TECHNICAL INFORMATION JDE

Type Coffee Vending Machine	Model 9100	T.I. NO 01 - 2017		
Serial Number 71011428	Subject ADAPTER FOR TEFLON HOSE - NOZZLE	ISSUED FOR (X)	Action Information	<input checked="" type="checkbox"/>

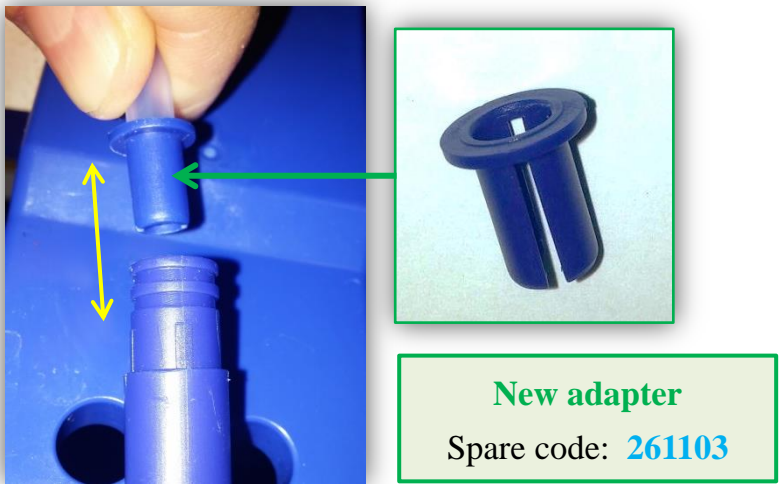
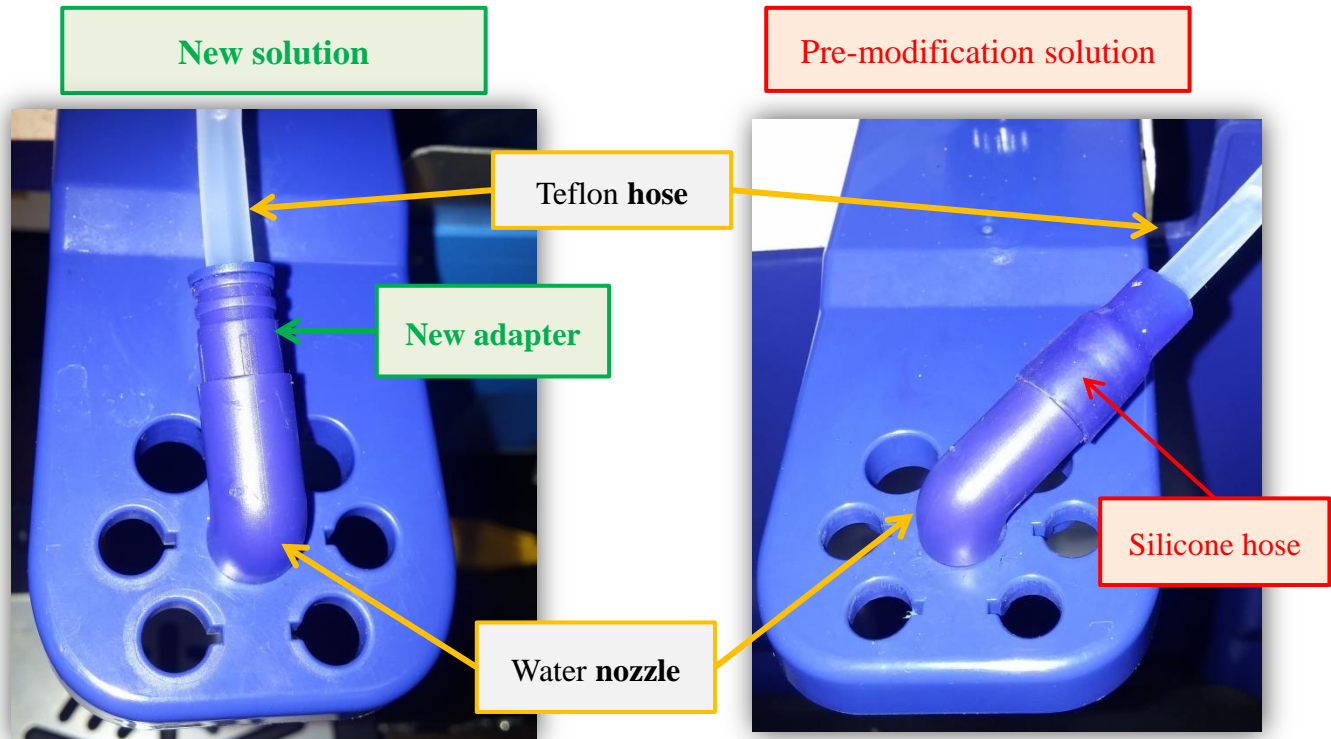
The adapter goal it's to facilitate the teflon-hose fit with the water-nozzle.

The **new adapter** replaces the silicone hose and allows to fit easily the *teflon-hose* with the *water-nozzle*.

Machines concerned by modification from S/N **71011428.**

New adapter spare code: **261103**

For machines previous to S/N above it's possible to mount the **new adppter**.
